# SITE PLAN REVIEW AND APPEARANCE BOARD

## CITY OF DELRAY BEACH

### ---STAFF REPORT---

**Downtown Delray Medical Centre – Extension Request for the Class V Site Plan, Landscape Plan and Architectural Elevations, associated with the construction of two 1-story 6,500 sq. ft. medical office buildings. The proposal includes the installation of a 46-space parking lot with 10 on-street parking spaces along the alley r-o-w and 10 spaces along SE 6<sup>th</sup> Street r-o-w for a total of 66 parking spaces. The property is located at 530 SE 6<sup>th</sup> Avenue.**

ARCHITECTURAL SITE PLAN

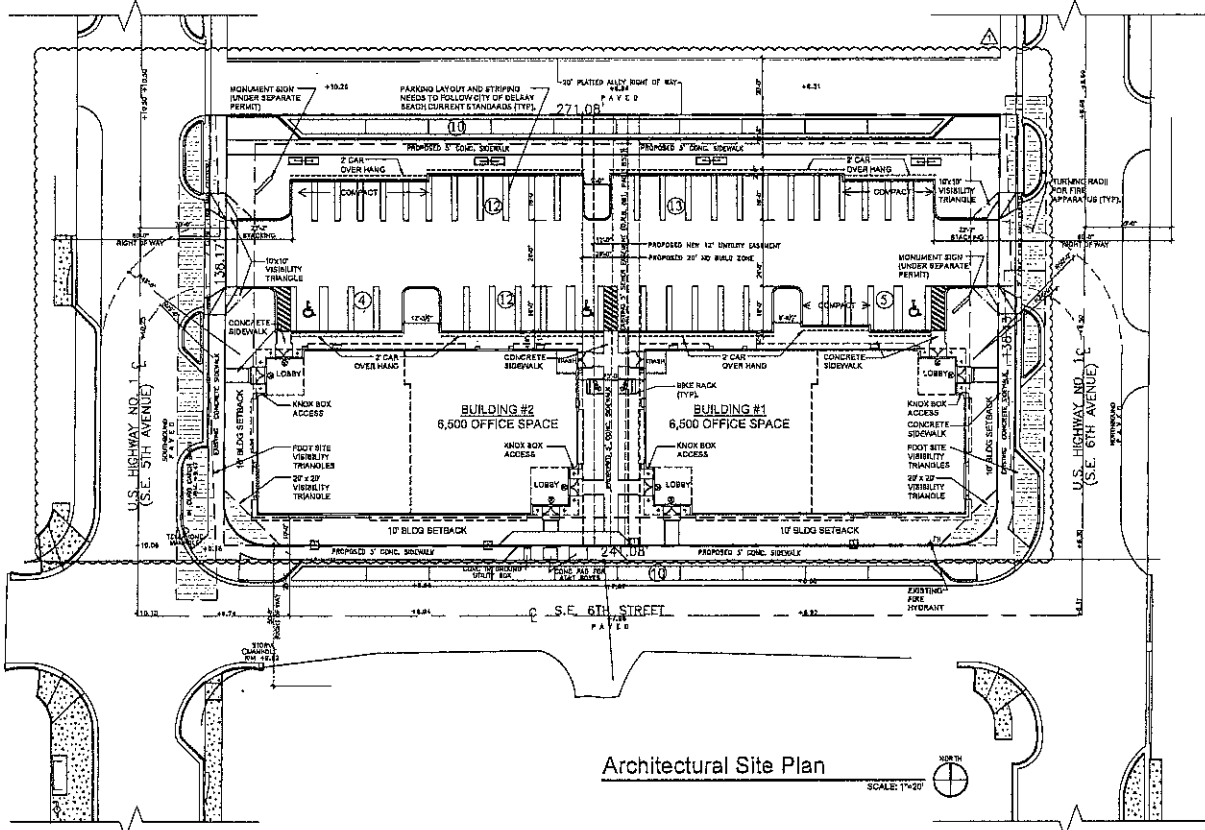
4. Provide note that parking layout and striping needs to follow City of Delray Beach current standards. Provide latest Parking Lot Detail RT 4.1 and Typical Parking Space Details RT 4.2 A thru C, as applicable on Civil Plans. On plan view, indicate double striping at parking spaces.

***The applicant has indicated that the Site Plan (sheet SP-1) has been revised and double striping is being shown along with a note regarding design standards***

sheet:  
**L-1**  
1 of 4 sheets

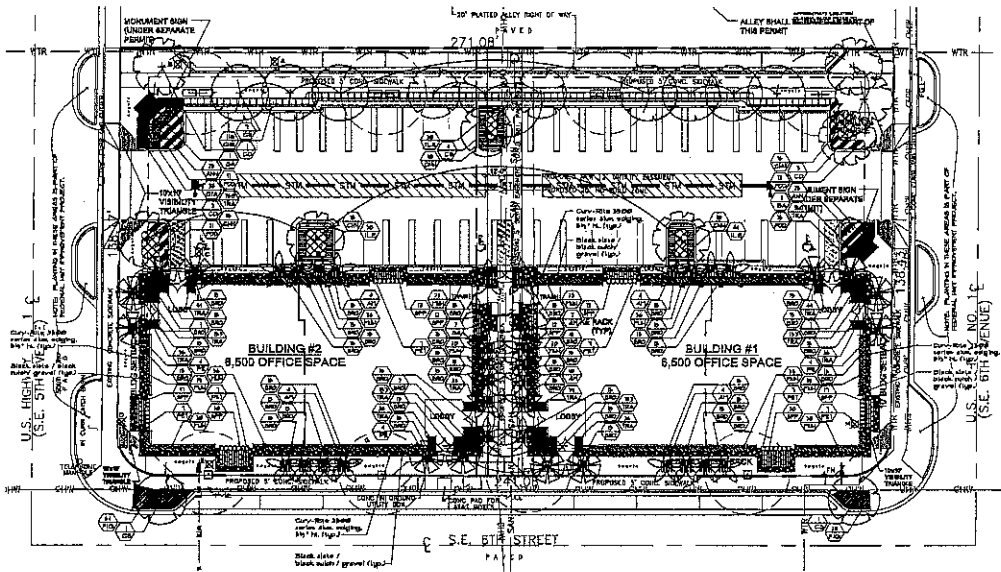
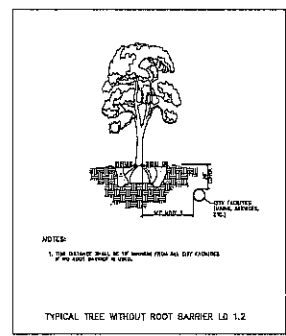
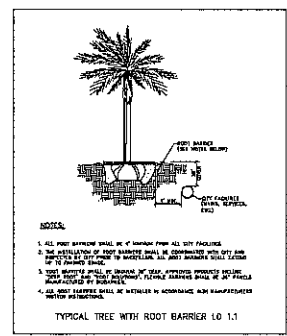
7. Provide the following note on both the Engineering Plans and the Landscape Plans that, "any trees or shrubs placed within water, sewer or drainage easements shall conform to the City of Delray Beach Standard Details; LD 1.1 & LD 1.2." These Details are to be shown on the Landscape Plans. Note and details found in Engineering Plans, these need to be included in Landscape Plans.

3. Per LDR 4.6.16(H)(3)(n), all existing soil within landscape areas adjacent to vehicular use areas is required to be removed (to 30” below grade), inspected and then replaced with a sixty to forty (60/40) mix of sand to topsoil, native soil that has been screened of rock or another mixture suggested by the Landscape Architect. Provide note on plans. Include in plans the illustration found in LDR 4.6.16(H)(3)(n).

**See Civil Sheet 1 for note. The details have also been provided on sheet L-1 and the note has been added as requested.**

***The detail has been added.***
